PREVOST

Instruction Sheet

IS-09048

DVD PLAYER REPLACEMENT

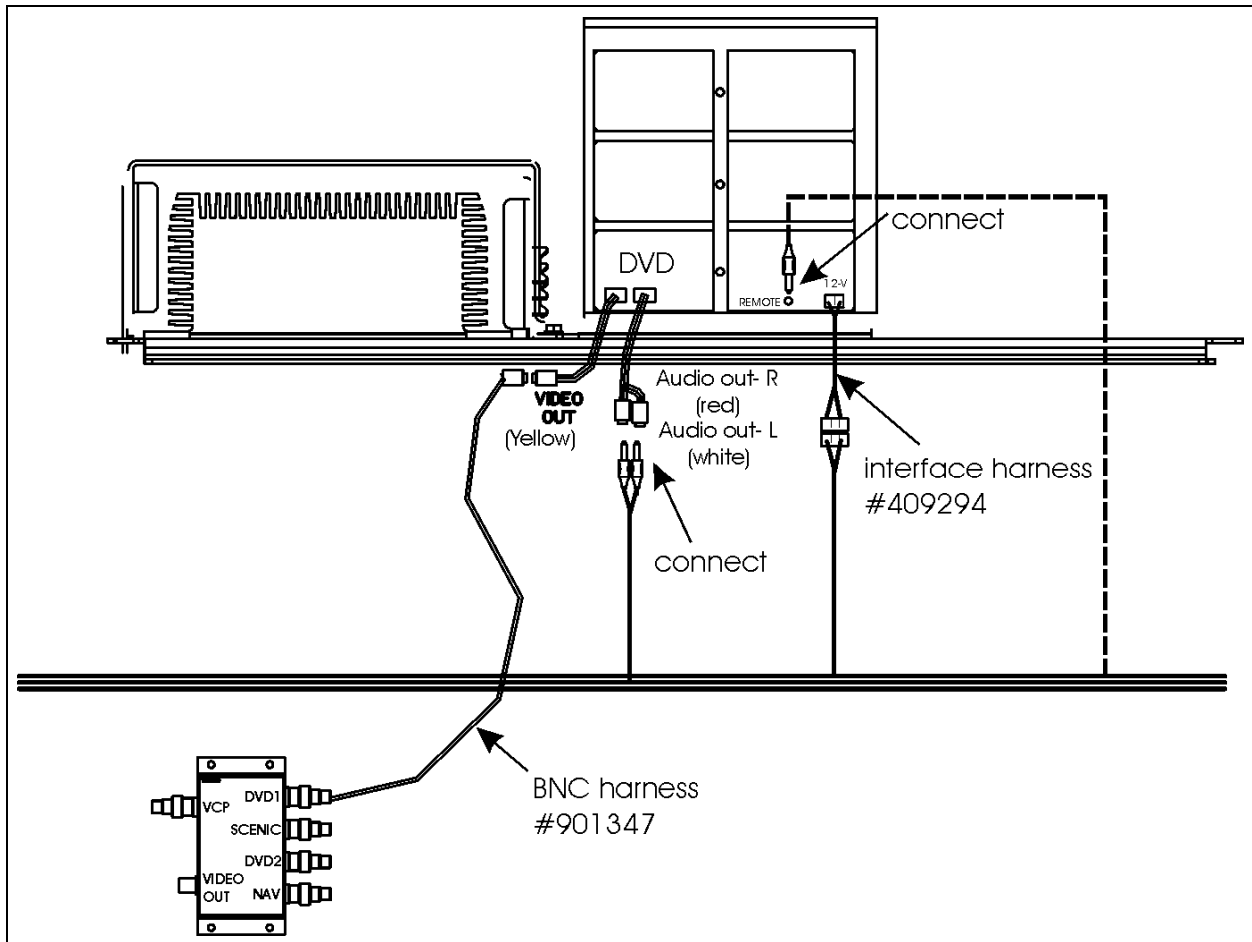
3. Slide the DVD player into the DIN cage and attach trim frame as described in the DVD player owner's manual.
4. Fix the DVD player using the mounting stud located at the back of the unit. Because the mounting stud is not located at the same place than the previous DVD player, use bracket #406358. Drill a second hole in the audio/video components support and use the included hardware.
